May 14, 2019

**ADDENDUM NO. FIVE (5)
VILLAGE CREEK STATE PARK
HARDIN COUNTY, TEXAS
PROJECT NO. 128695
FACILITY DAMAGE REPAIRS**

Notes Added to Drawings:

1 ELECTRICAL FIRST FLOOR ELECTRICAL AND POWER PLAN
E3.1 SCALE: 1/4" = 1'-0"

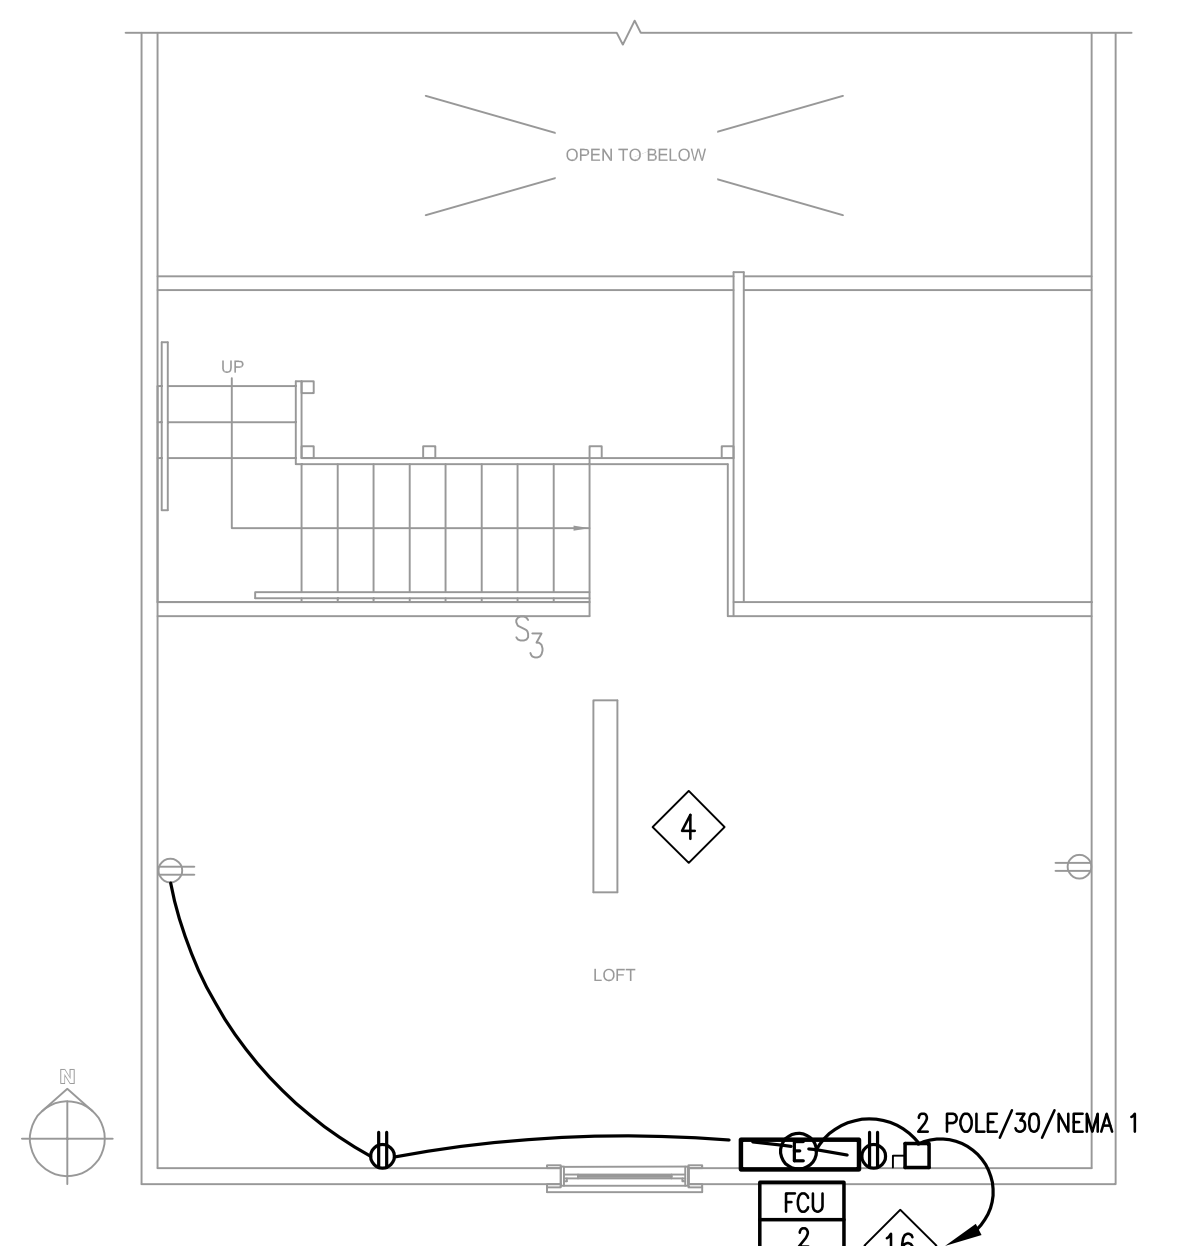
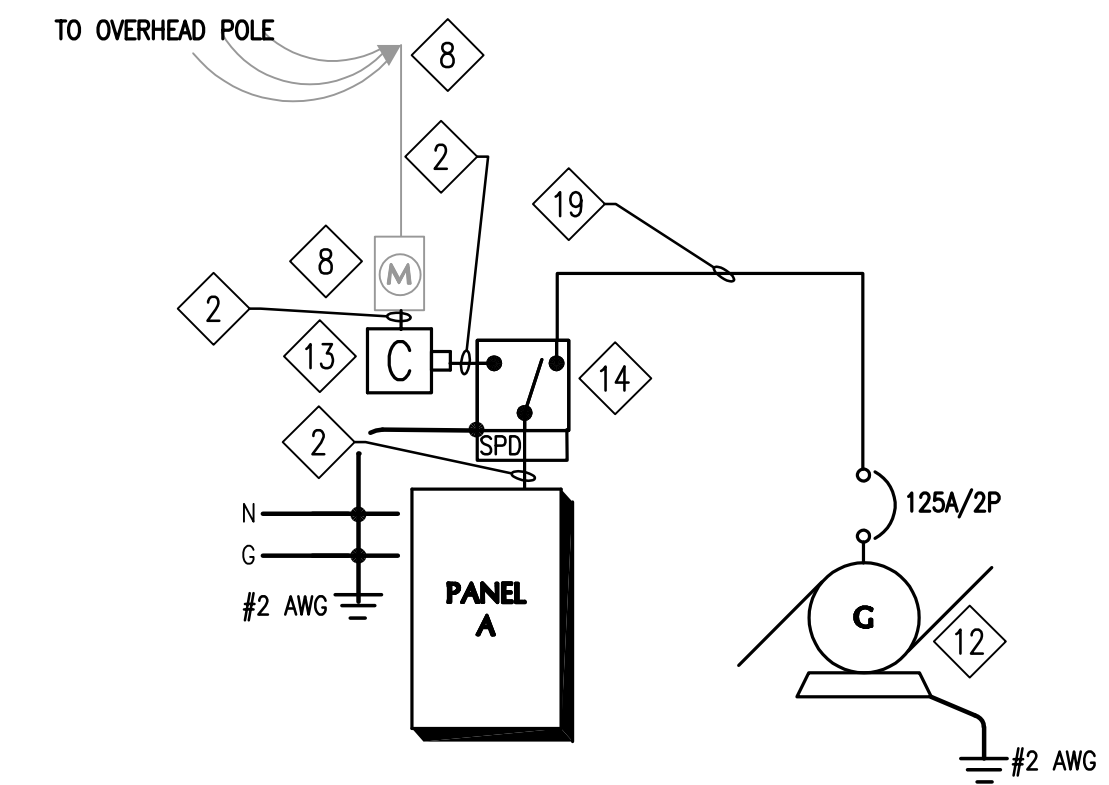
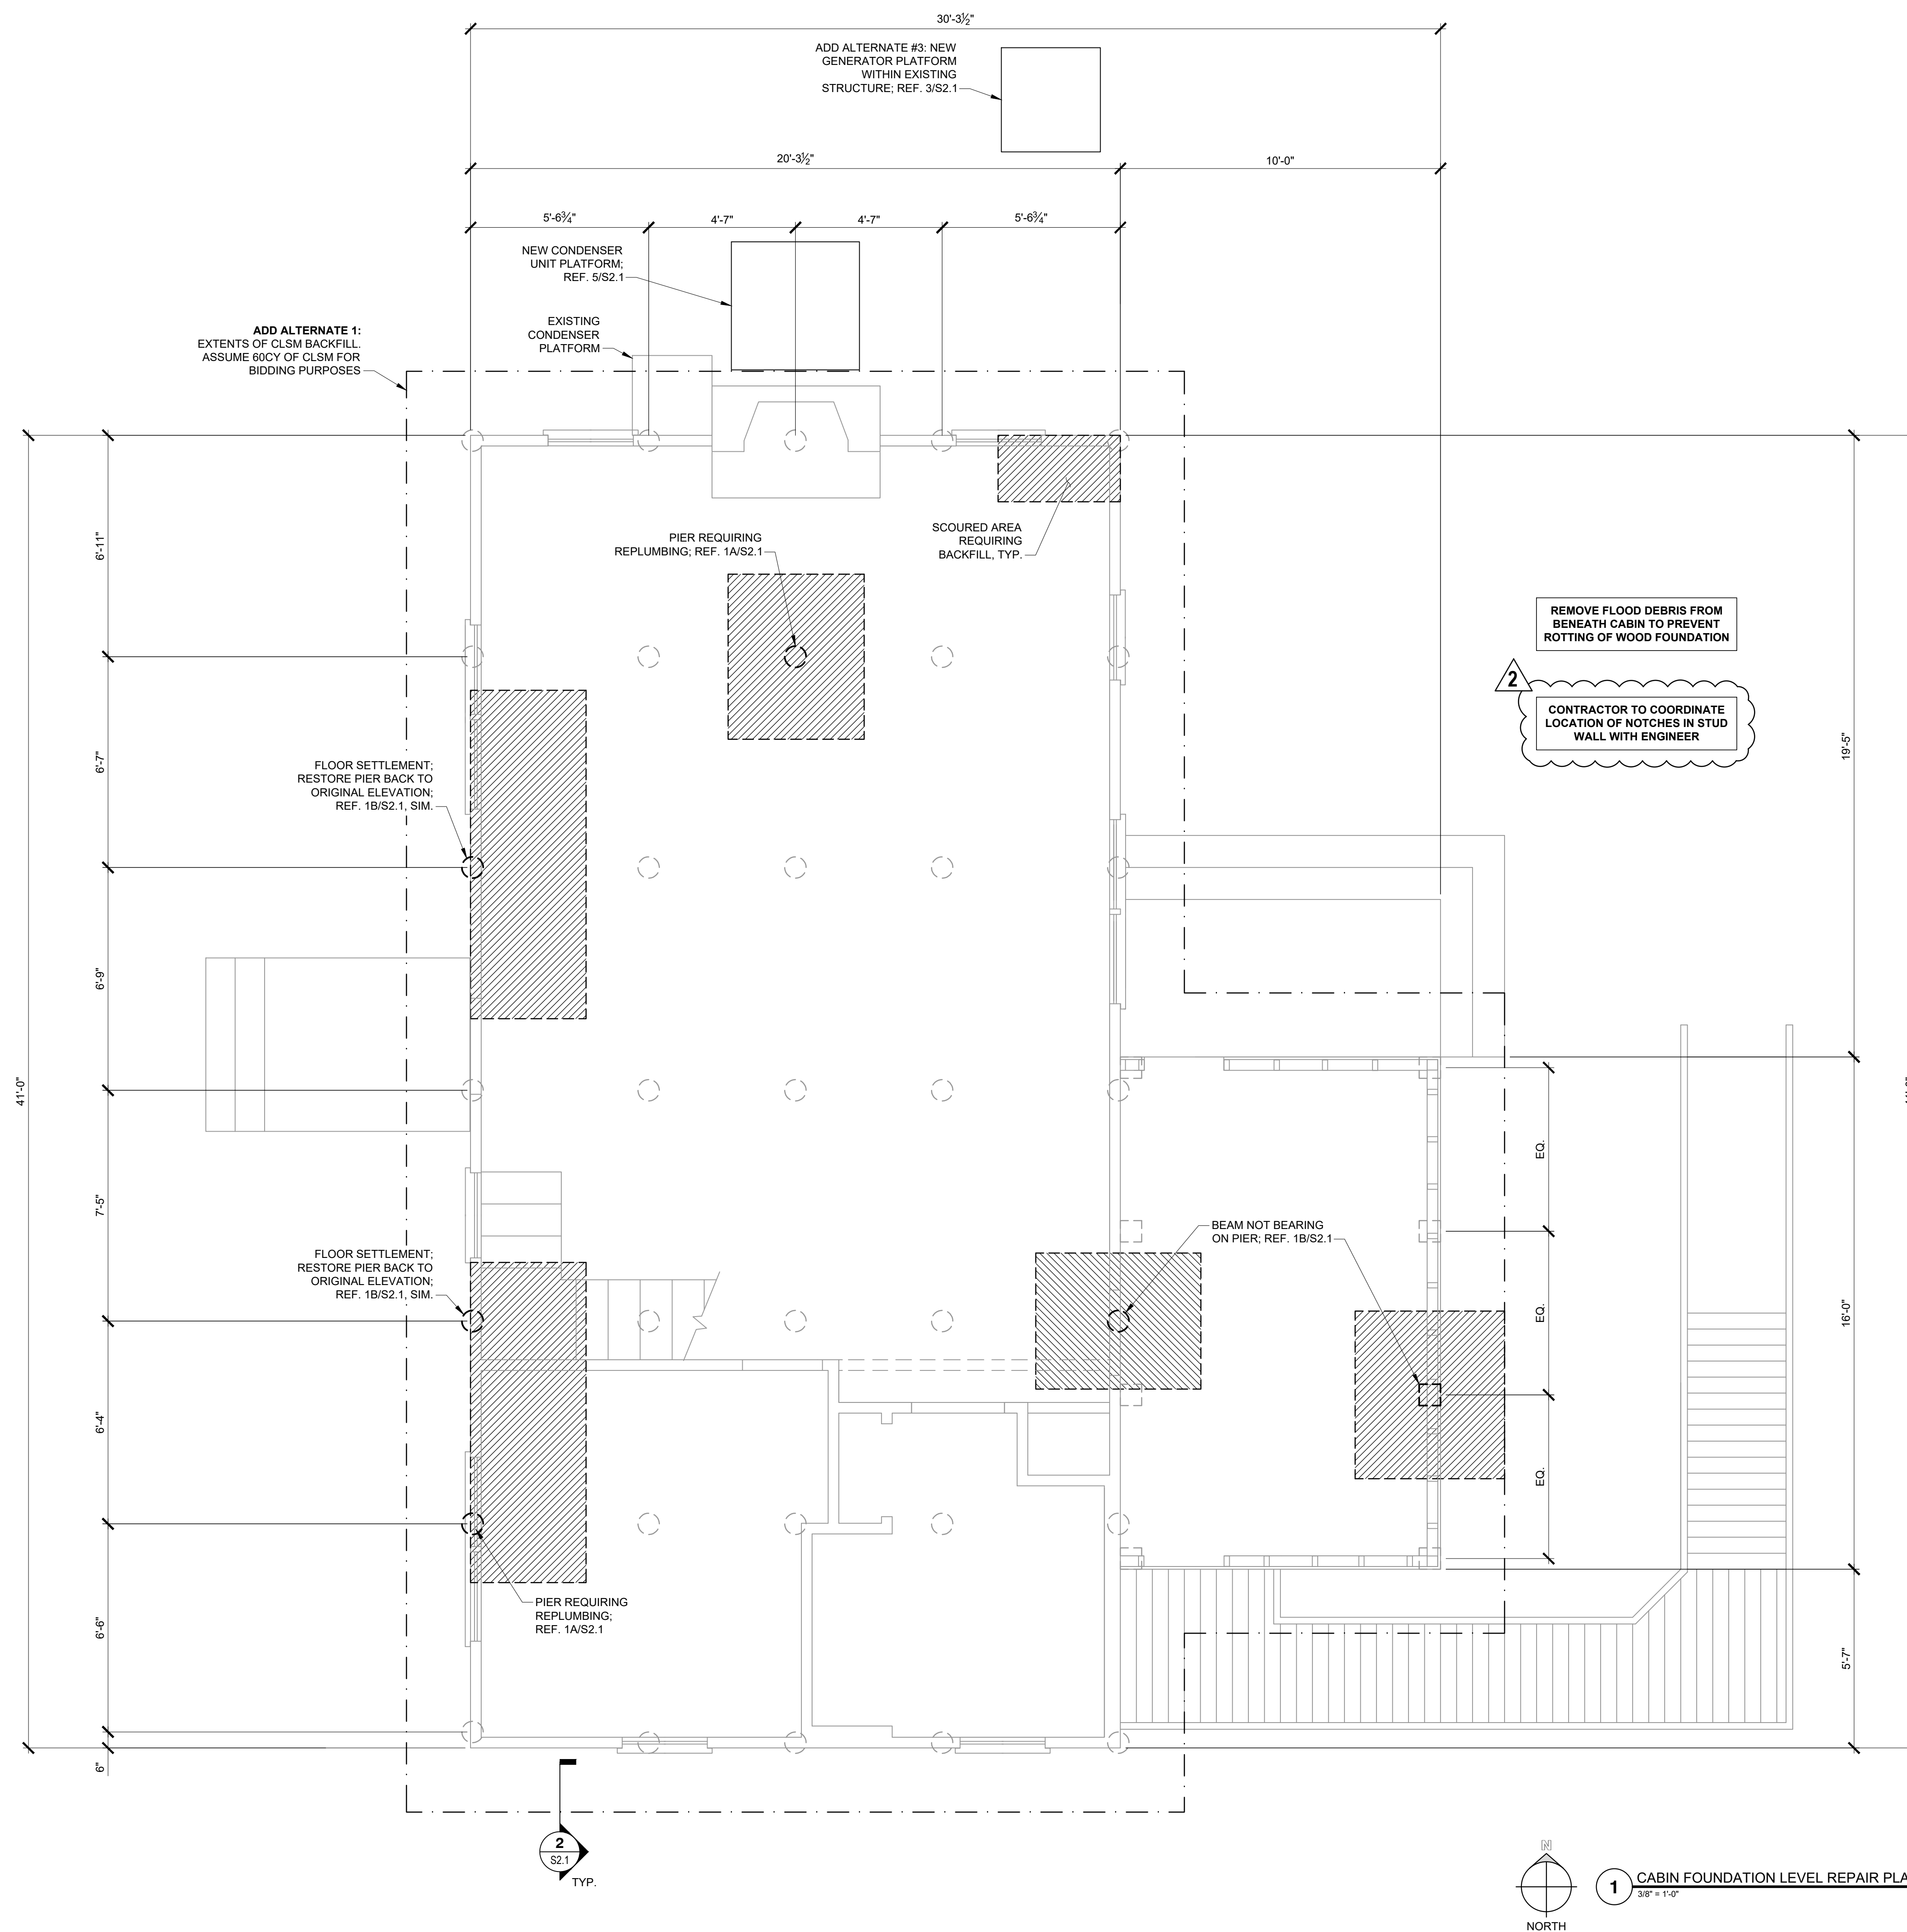
- 1. The only possible way to run EMT conduit in an existing Wood structure would be to notch the wall studs where conduit is needed to run through them this would likely cause structural vulnerabilities to the building, could we not utilize MC cabling ran above the minimum clearance and where exposed on ceiling above use EMT conduit?

ANSWER: In order to minimize the need to notch existing wall studs, the Contractor may utilize Metal Clad Cable above 48" A.F.F. if the structure is covered. EMT shall be used in the area below 48" A.F.F. and in exposed walls or ceilings. Notching of the existing wooden studs is allowed provided the locations are coordinated with engineer and do not exceed the notch provisions provided in the International Building Code.

- GENERAL NOTES**
1. REFERENCE THE G SERIES SHEETS FOR MOUNTING HEIGHT DIAGRAMS FOR ALL DEVICES INCLUDING SWITCHES AND RECEPTACLES.
 2. ROUTE CONDUIT AND WIRING ABOVE WAINSCOT TRIM ON 5/8" DIA. A MINIMUM OF 48" AFF.
 3. THE GENERATOR, TRANSFER SWITCH, AND NEW PLATFORM FOR THE GENERATOR ARE A PART OF ALTERNATE #3. THE CONDUIT AND WIRING ASSOCIATED WITH THE GENERATOR AND TRANSFER SWITCH ARE PART OF THE BASE BID. UNDER THE BASE BID, TERMINATE THE FEEDER FOR THE GENERATOR IN A 12" X 12" X 6" DEEP WEATHERPROOF JUNCTION BOX INSTALLED FLUSH WITH GRADE.
 4. ALL WIRING DEVICES IN THE CABIN SHALL BE ARC FAULT STYLE, TAMPER RESISTANT RECEPTACLES PER NEC SECTION 210 OF THE NATIONAL ELECTRICAL CODE.
 5. EMT CONDUIT SHALL BE USED IN AREAS BELOW 48" AFF. METAL CLAD CABLE MAY BE UTILIZED ABOVE 48" AFF IF THE STRUCTURE IS COVERED. EMT CONDUIT SHALL BE USED IN EXPOSED WALLS OR CEILINGS.
